STATE OF DELAWARE
EXECUTIVE DEPARTMENT
OFFICE OF
STATE PLANNING COORDINATION

RE: PLUS review – PLUS 2005-05-16; Water's Run

LANDDESIGN, inc- 8/12/05

Water's Run

MULTI-USE PATHWAY
NOT TO SCALE

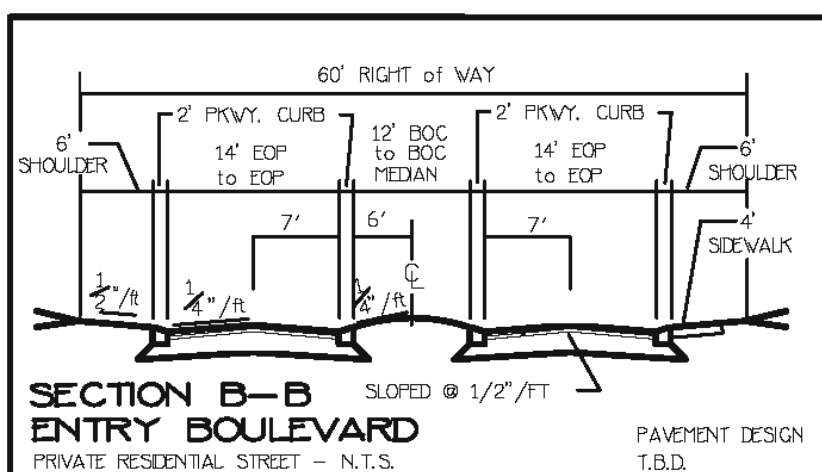
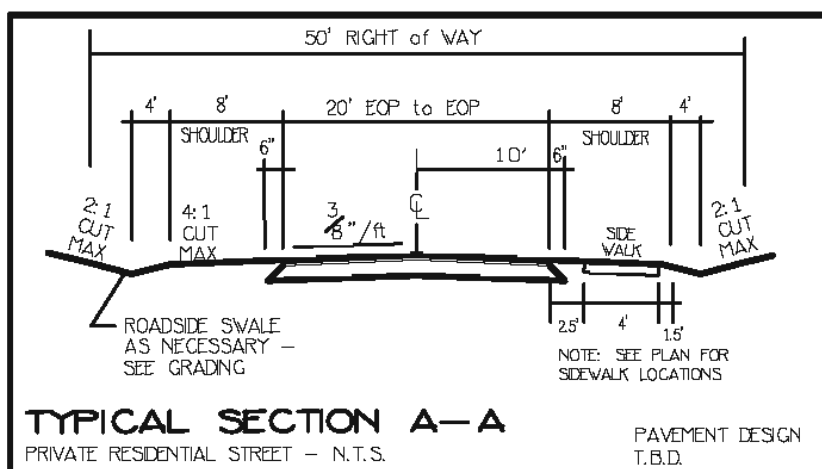
A paved multi-modal path, located in a 15-foot wide permanent easement will be required on both sides of the road. This would be contrary to sensitive design of natural factors since non-tidal wetlands would most likely be affected on the easterly portion of this project and is an excessive requirement to pave surfaces. This is not in keeping with an environmental conscious design. We hereby propose that the state judicially review the option of a multi-modal path along the west side with possible extension to the north by way of cross walk

- 2) A paved multi-modal path, located in a 15-foot wide permanent easement is required across the frontage of the site. Preliminarily, paths should be provided on both sides of the road. We will accommodate a path primarily at the entrance to this project and then to the east side of the road north of the entrance. This will avoid any conflicts with 404 lands.
